Appendix L – Drainage Feasibility Study

MEMORANDUM

Subject: Spieker Senior Continuing Care Community San Carlos Drainage Feasibility

Re: Spieker Senior Continuing Care Community Project (GP20-0001) – second round

Proposed Outfall Plan & Profile with Existing Utilities

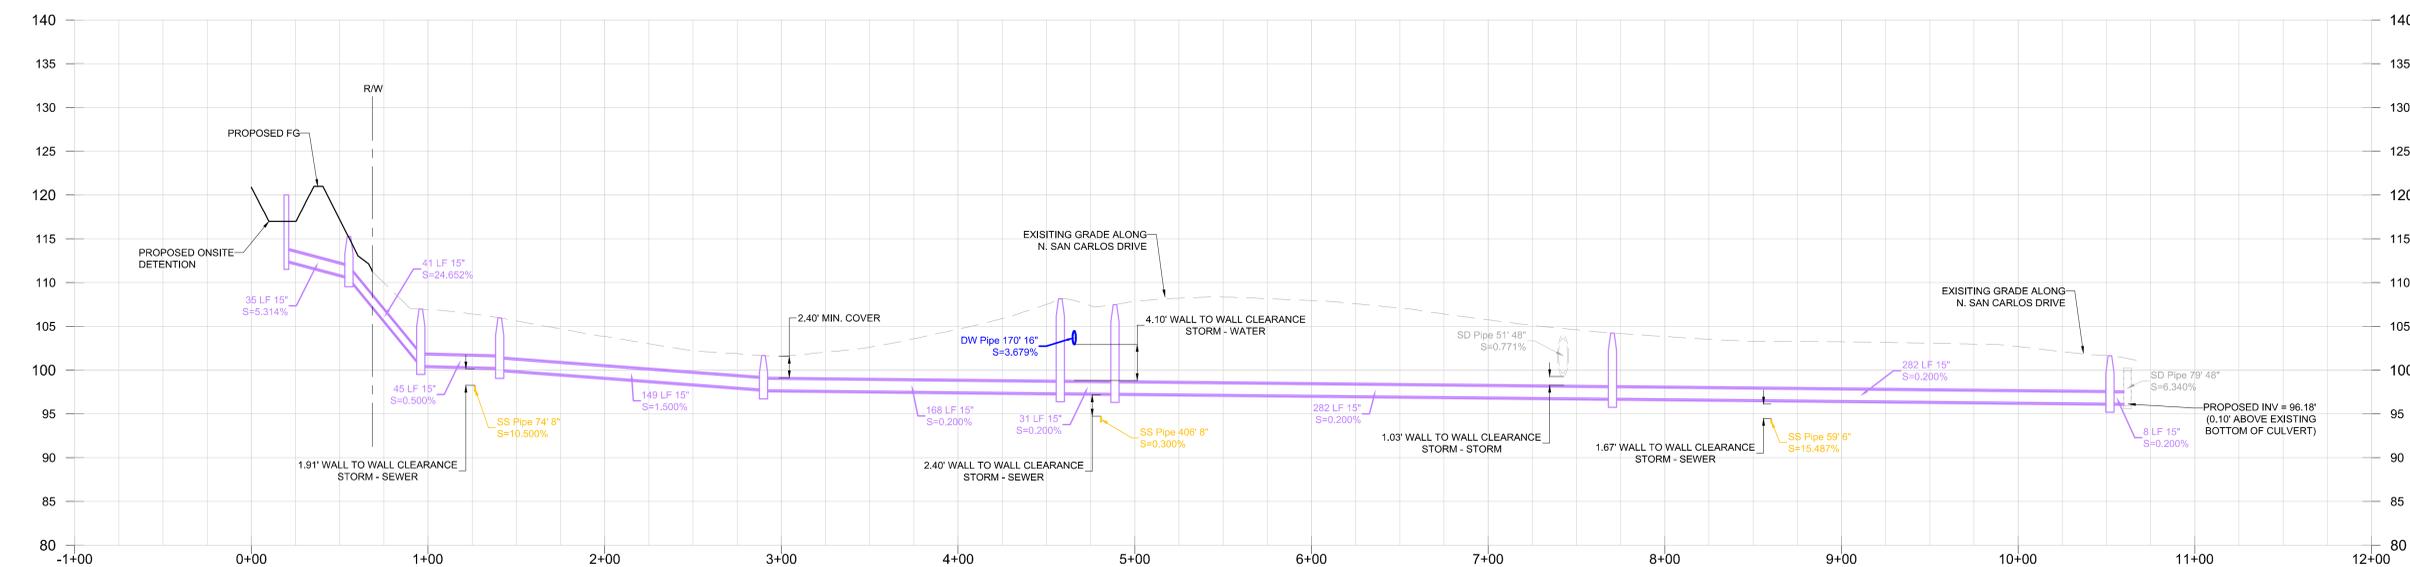
- d. For DMA #, Outfall 5 (drainage at N San Carlos EVA), please note that the City will accept and actually prefers PVC over RCP. Also, please provide response/clarification of CCWD comment No. 2 (no response provided in RTC) that “No drainage from the project site shall be allowed to go onto CCWD or Reclamation property”, particularly with regard to Options 1 and 2. Both options will require review and approval by the City and CCWD. Option 1 will require crossing the Contra Costa Canal and thus require review and approval from the BOR. Evaluation of both options will need to include determination of necessary easements, ensure utility separation, evaluate impacts of outfall to canal, and include design of outfall to mitigate impacts and address long-term maintenance concerns.

The existing 8" sewer main in North San Carlos Drive will remain, so the proposed water main and storm outfall were designed to accommodate this alignment. The horizontal separation required by CCWD has been met along the entire length of the proposed water main. The minimum horizontal clearance between the existing 8" sewer main and the 15" PVC storm outfall is 5 feet, which is greater than the 3 feet clearance that Central San requires. Additionally the storm drain was designed to cross both the existing sewer and proposed water mains at an angle greater than 45 degrees (See Appendix E).

The vertical alignment was determined based on a combination of the existing crossing utilities as well as the design criteria above. The determining factors for the vertical alignment is the 48 inch Ygnacio Canal culvert crossing North San Carlos Drive and the invert of the ultimate discharge point in the 4 by 4 box culvert. Both culvert's inverts and locations along the proposed storm alignment can be seen in Appendix E. Based on our site visit, the 48 inch culvert is assumed to be RCP pipe and the thickness of the pipe walls have been shown accordingly.

A connection into the public storm drain system at the 4 by 4 box culvert can be made at an invert of 96.18 feet, 0.1 feet above the existing bottom of the box culvert. Using this minimum invert elevation and ensuring the vertical clearance is 1 foot or greater at the 48 inch RCP Ygnacio Canal culvert further upstream, the result is a 15 inch PVC conduit at a slope of 0.002 feet per foot length (See Appendix E). This is less than the 0.005 city requirement. BKF determined that 1 foot of clearance is a conservative initial design for a storm to storm crossing. This clearance can be adjusted to provide a greater slope if necessary. A 15 inch PVC pipe sloping at 0.002 feet per foot length flowing full results in a pipe velocity of 2.35 feet per second (See

Appendix H). This pipe velocity falls slightly below the Urban Drainage Design Manual's recommendation of 3 feet per second as a self-cleaning velocity. However, the final design of the storm outfall will include access hole spacing in accordance with the Urban Drainage Design Manual to ensure adequate access for cleaning the outfall, as well as a detailed maintenance plan for the storm drain.

The minimum cover along the outfall, resulting from the infrastructure described above, is 2.4 feet from the existing pavement surface on North San Carlos Drive. This depth is greater than the 1 foot required by Caltrans. The utilization of onsite storage to limit the peak flow within the outfall to the capacity of the 15 inch PVC pipe will ensure that the hydraulic grade line requirement of 18 inches is also met.
